Attachment 5 – Stormwater and Flooding Response

5001_23_03_03_council rfi response_rev2.docx

**RE: EAC MASTERPLAN DA2022/75
EMMANUEL ANGLICAN COLLEGE
LOT 1 DP 1278708, 62 HORIZON DRIVE, WEST BALLINA.**

Ardill Payne & Partners (APP) has reviewed Council's Request for Additional information dated 20 September 2022 as well as subsequent meeting (6 October 2022) and email correspondence in relation to this RFI. Please find below a summary of the sites stormwater history as well as responses to items 5-9 of Councils RFI. The RFI items have been copied below in italics for ease of review.

Conceptual Overland Flow Path drawings

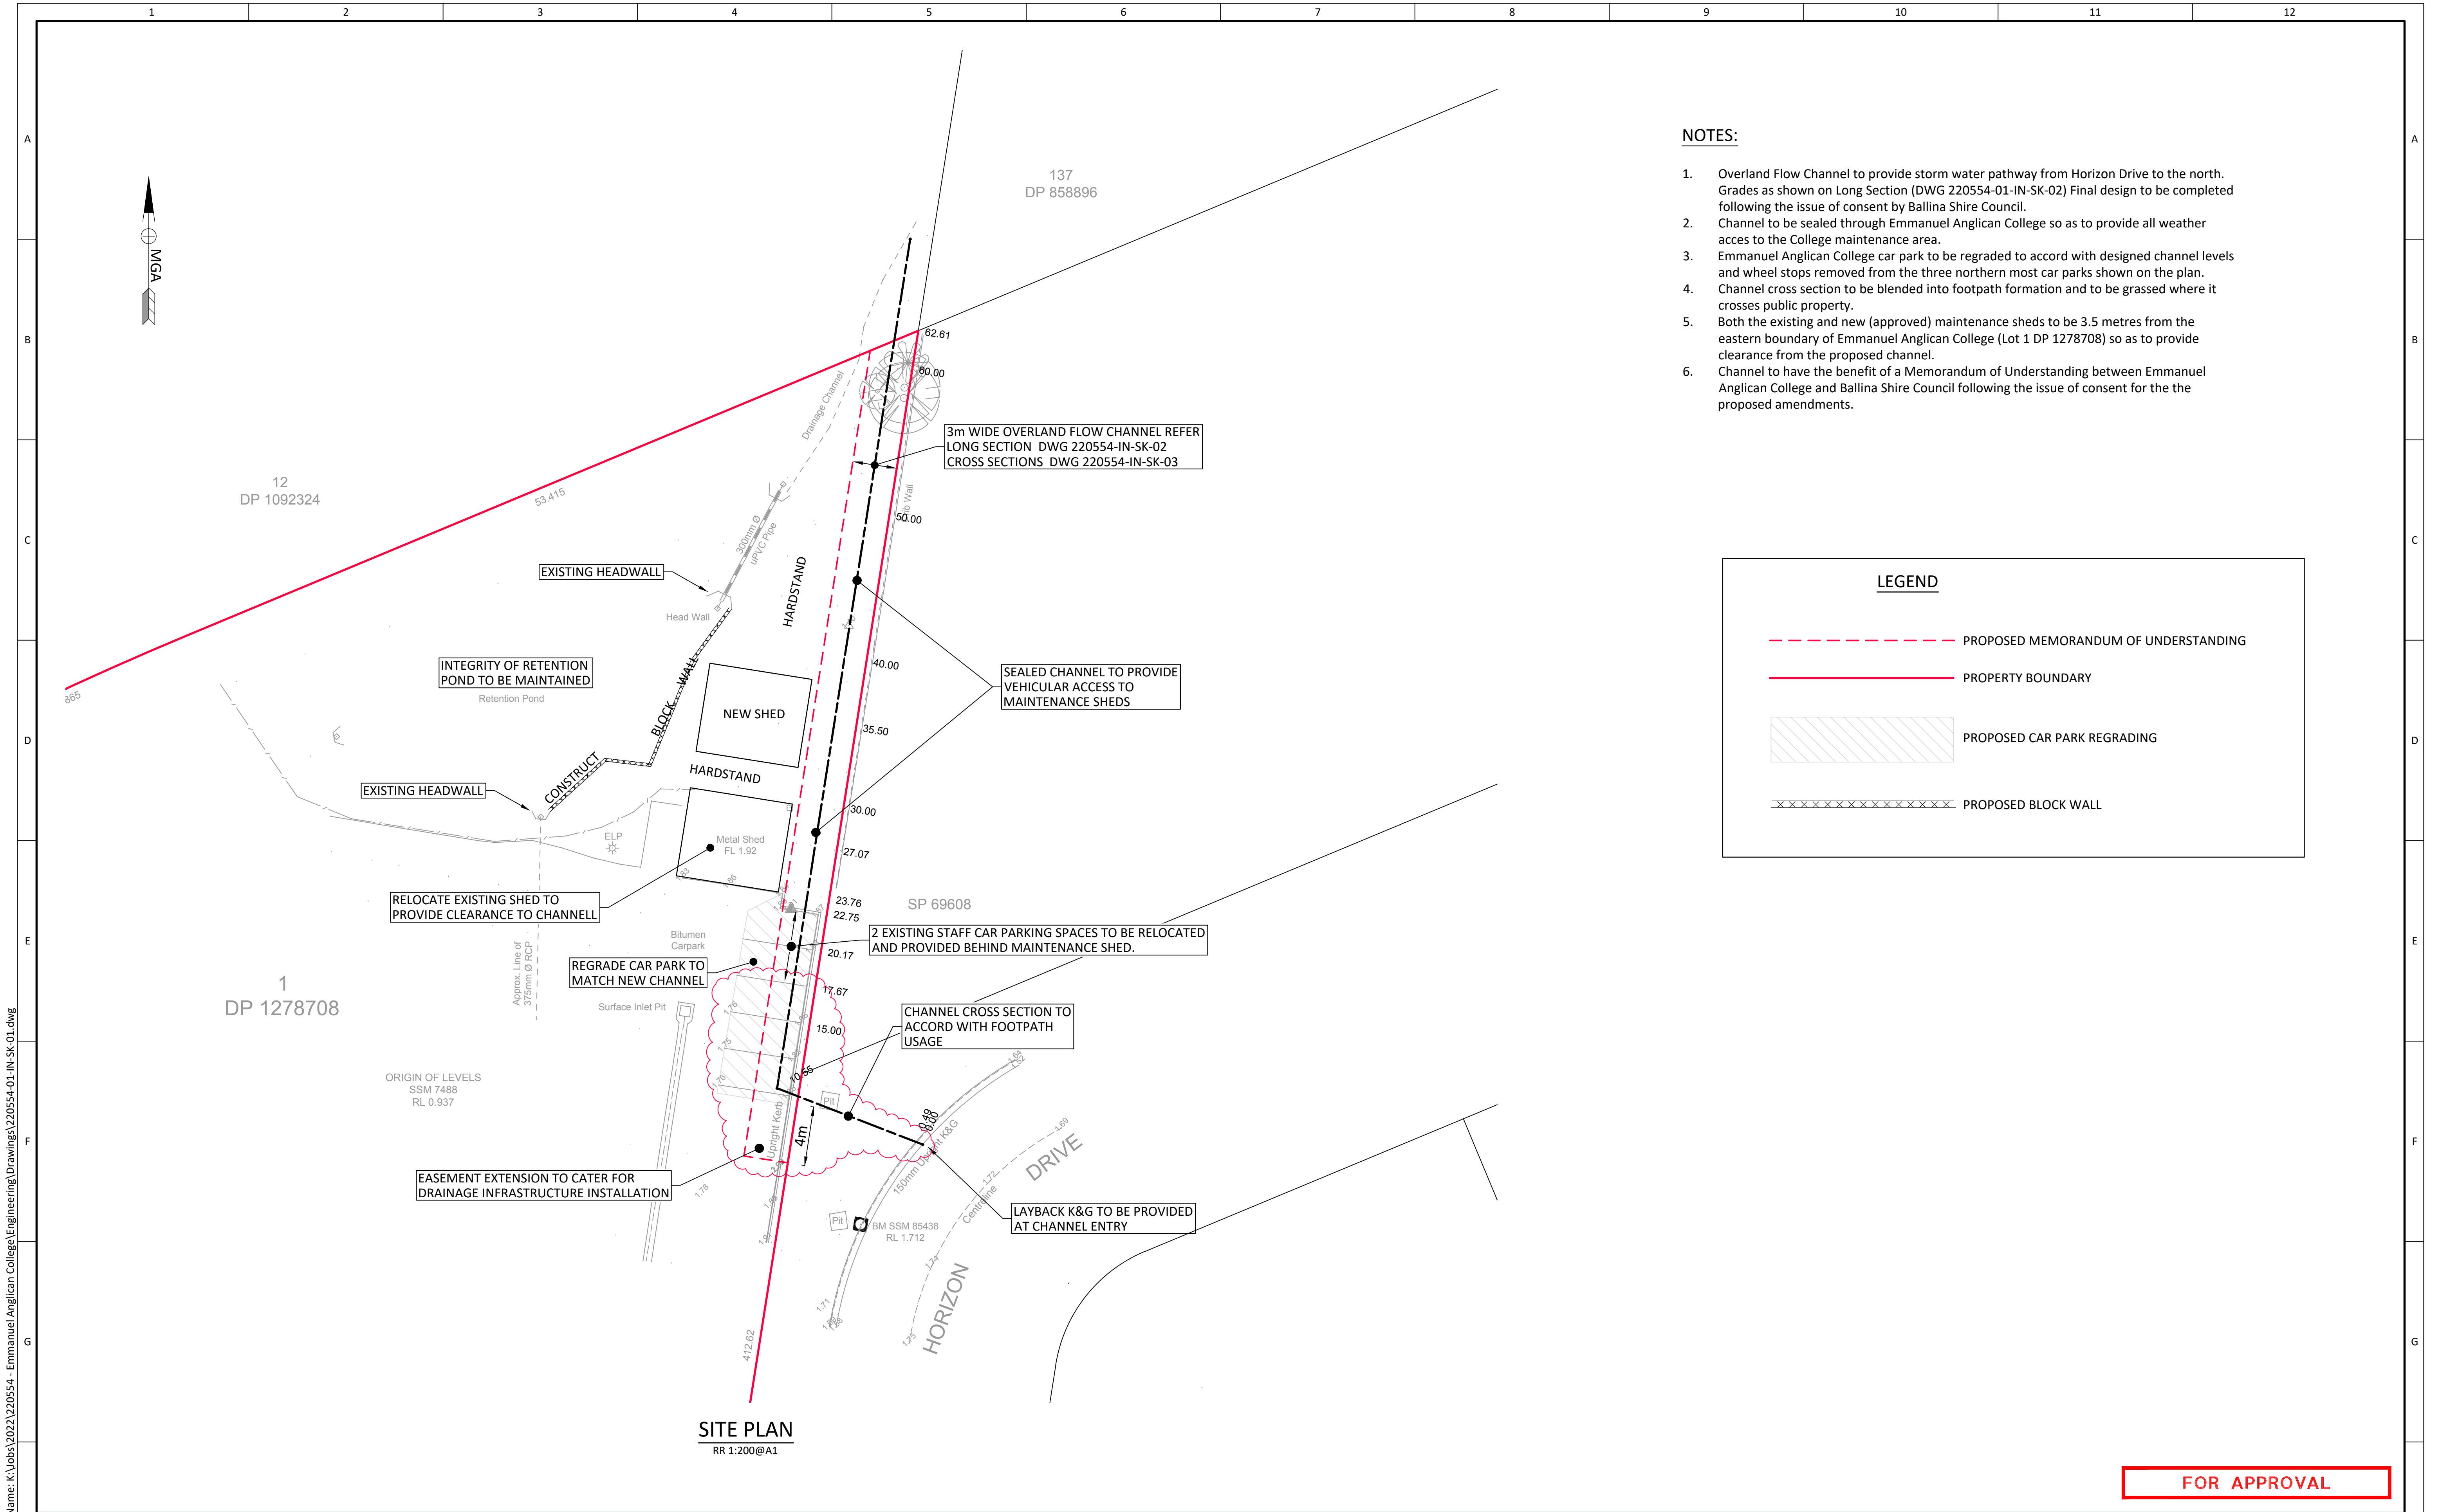
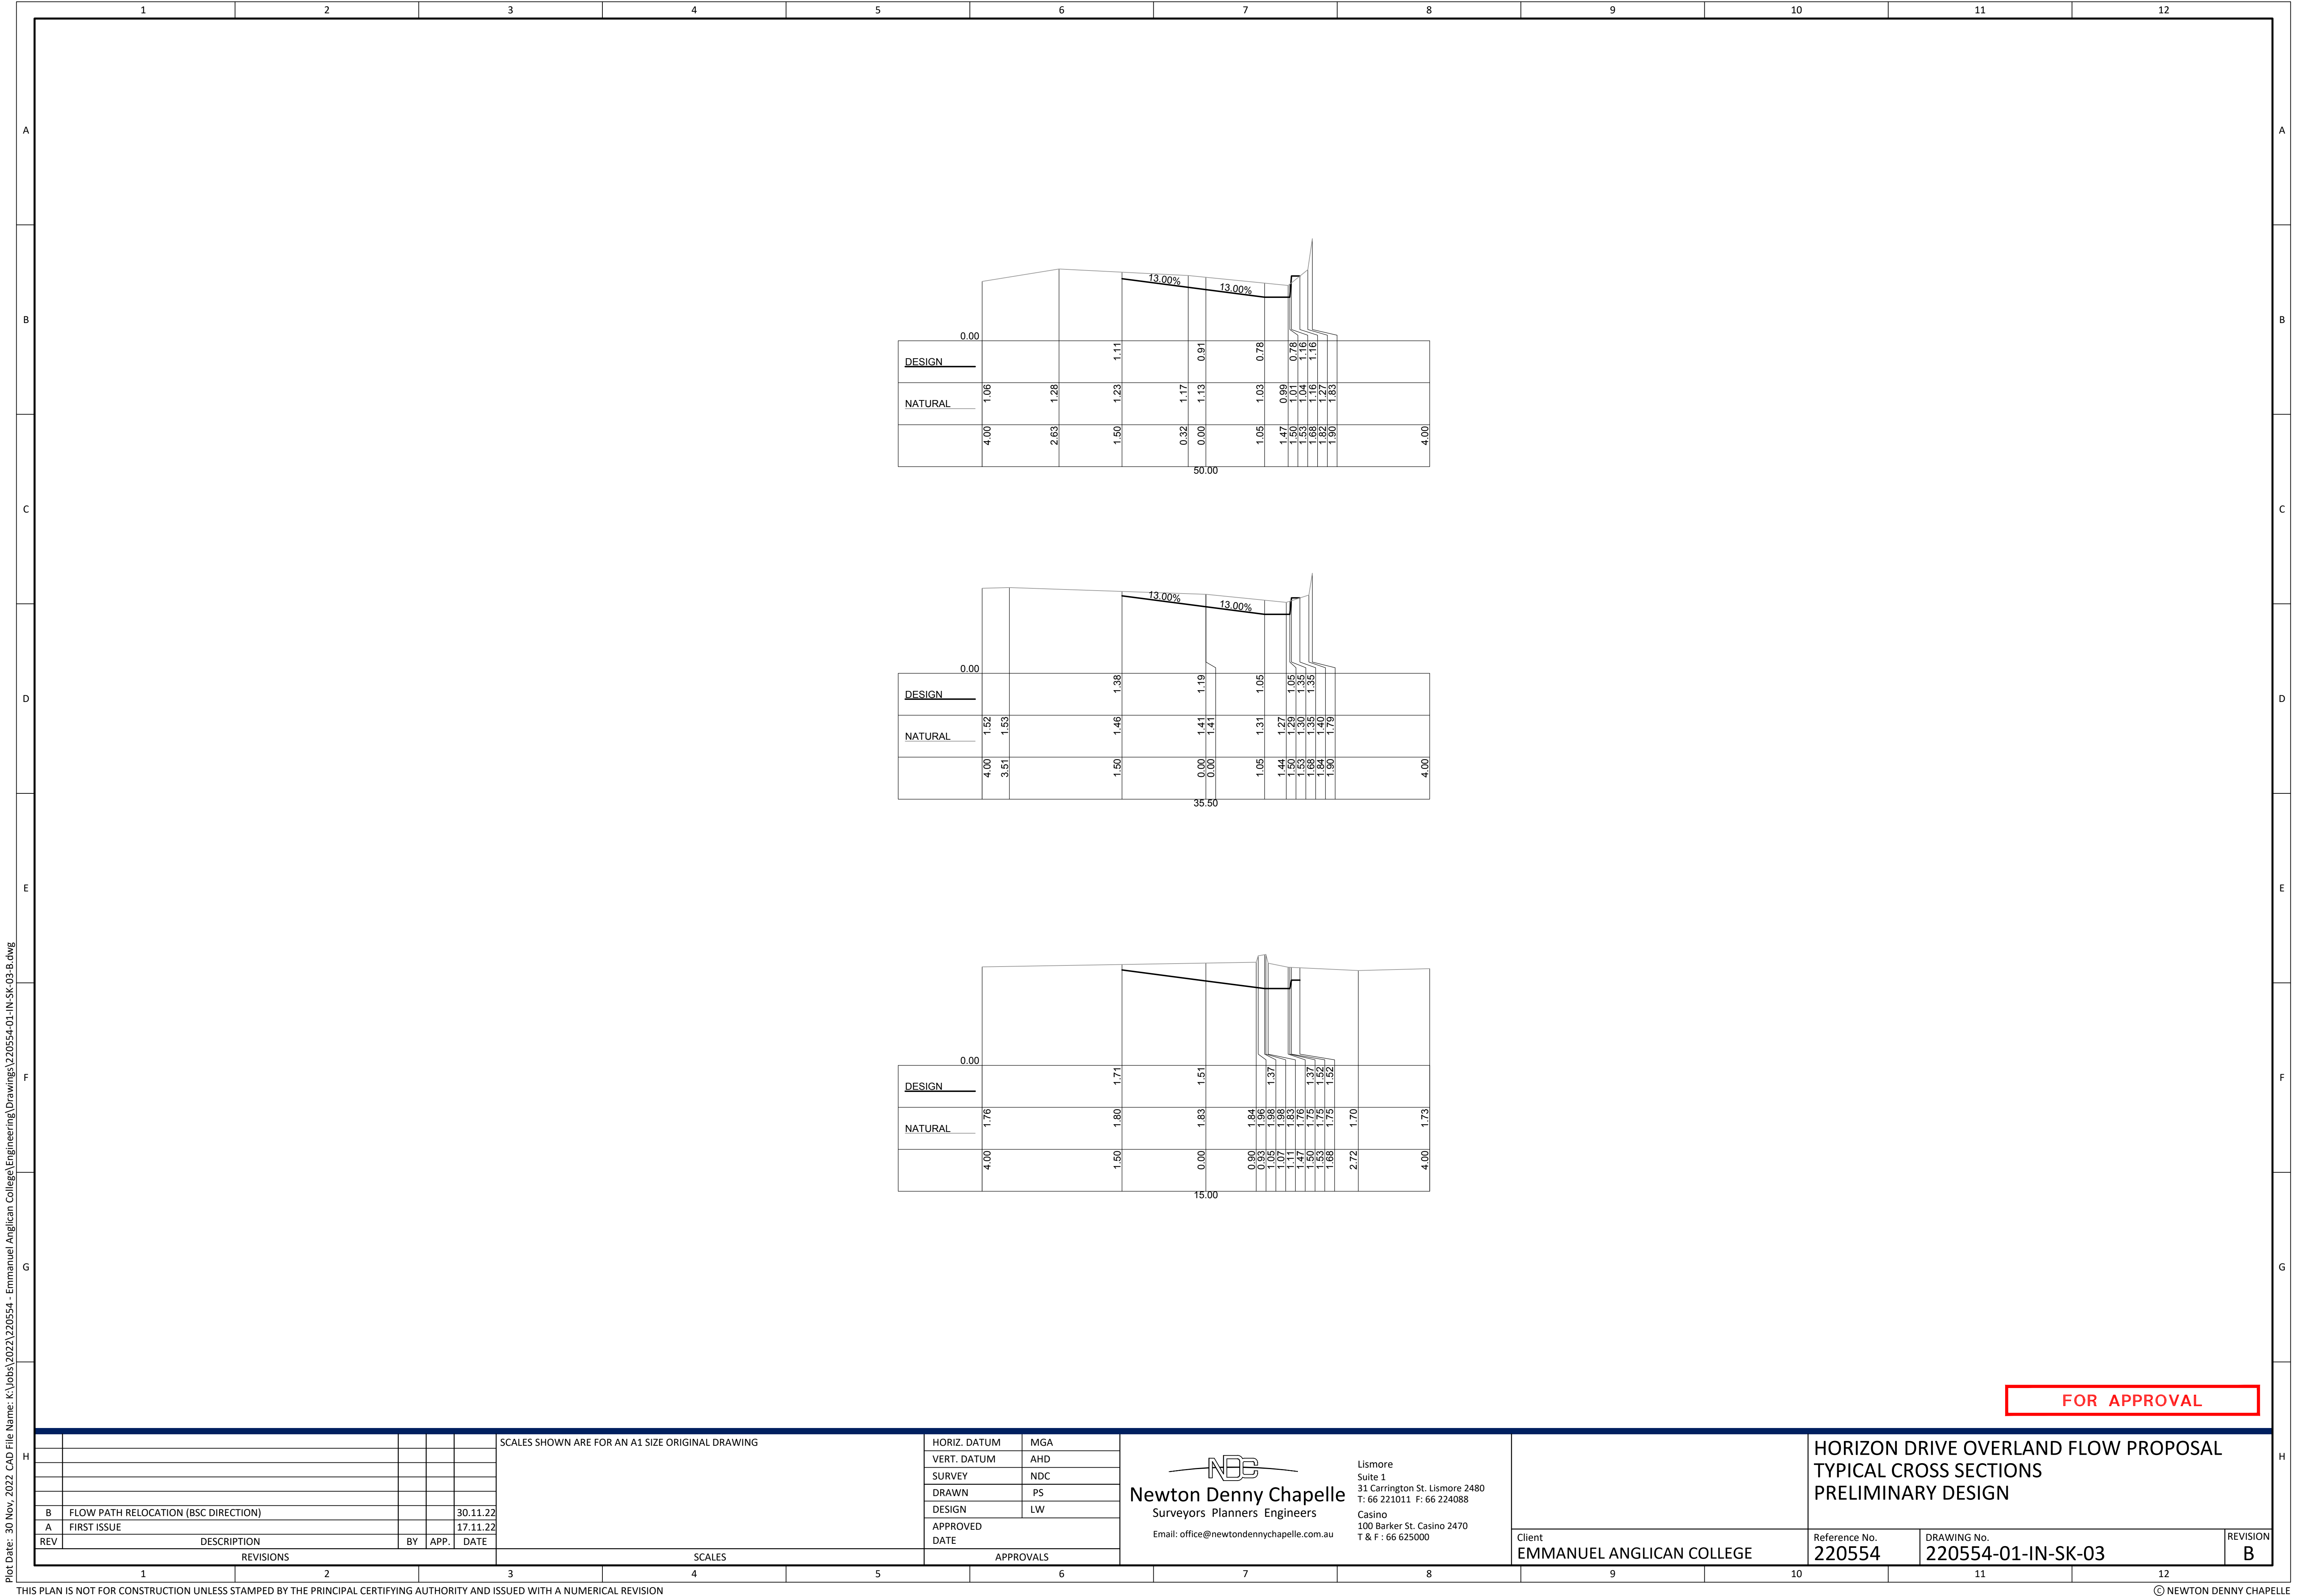
Council adopted the Ballina Island and West Ballina Overland Flood Study and Flood Protection Feasibility Study and Plan at the meeting held 26 May 2022. Subsequent investigations have identified a low point in Horizon Drive near the northern school site boundary and SP 69608. The proposal is required to include an unobstructed overland flow path from this low point to discharge to Lot 137 DP 858896.

As discussed within item 5 the College has provided a commitment to Council to investigate and facilitate an overland flow path from the north western corner of Horizon Drive through the site and north to Lot 137 DP 858896. Conceptual plans demonstrating potential gradients for an overland flow path through this area are enclosed within Attachment B.

Additional to overland flow path potential for pipe duplication through this corridor would also be possible if this were to provide a more favourable outcome. Council are currently modelling and reviewing the most effective solution within the available corridor. Formal agreements between the College and Council are being currently prepared.

- Overland Flow Channel to provide storm water pathway from Horizon Drive to the north. Grades as shown on Long Section (DWG 220554-01-IN-SK-02) Final design to be completed following the issue of consent by Ballina Shire Council.
